CITY OF ALBUQUERQUE

RE: 6417 San Ildefonso Dr. NW

Grading & Drainage Plan

Hydrology File: E11D035 Case # HYDR-2025-00189

Clark k Consulting Engineers
Edgewood, New Mexico 87015
Tele: (505) 281-2444 LOT 28, BLOCK 5, VOLCANO CLIFFS, UNIT 7
ALBUQUERQUE, BERNALILLO COUNTY, NM
6417 SAN ILDEFONSO DR., NW
Grading & Drainage
Plan

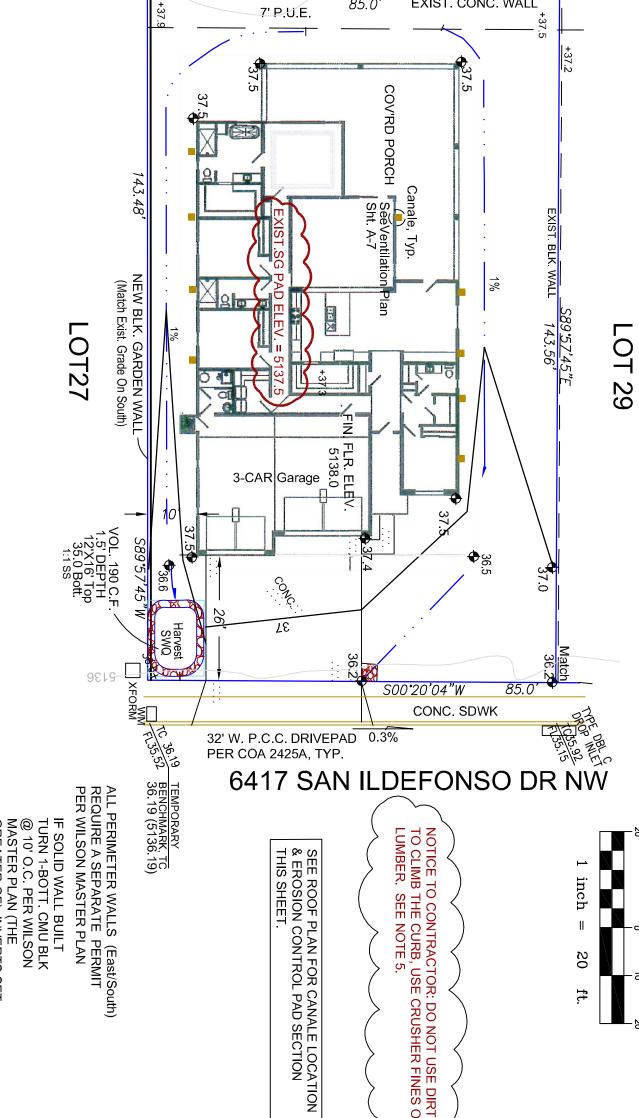
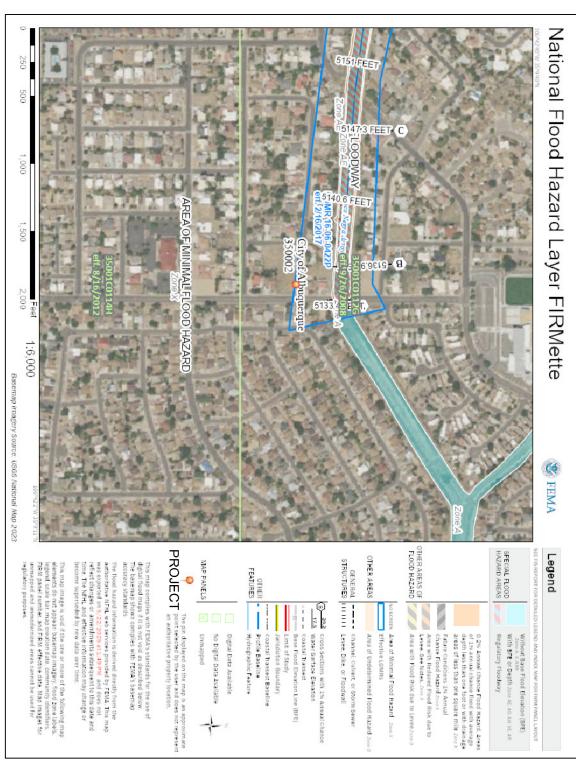
Based upon the information provided in your submittal received 05/16/2024, the Grading and Drainage Plan is approved for Building Permit and Grading Permit. Since this site is relatively flat and grades to the road, a pad certification is not needed for this project. Please attach a copy of this approved plan in the construction sets for Building Permit processing along with a copy of this letter.

1. Engineer's Certification, per the DPM Part 6-14 (F): Engineer's Certification Checklist For Non-Subdivision is required.
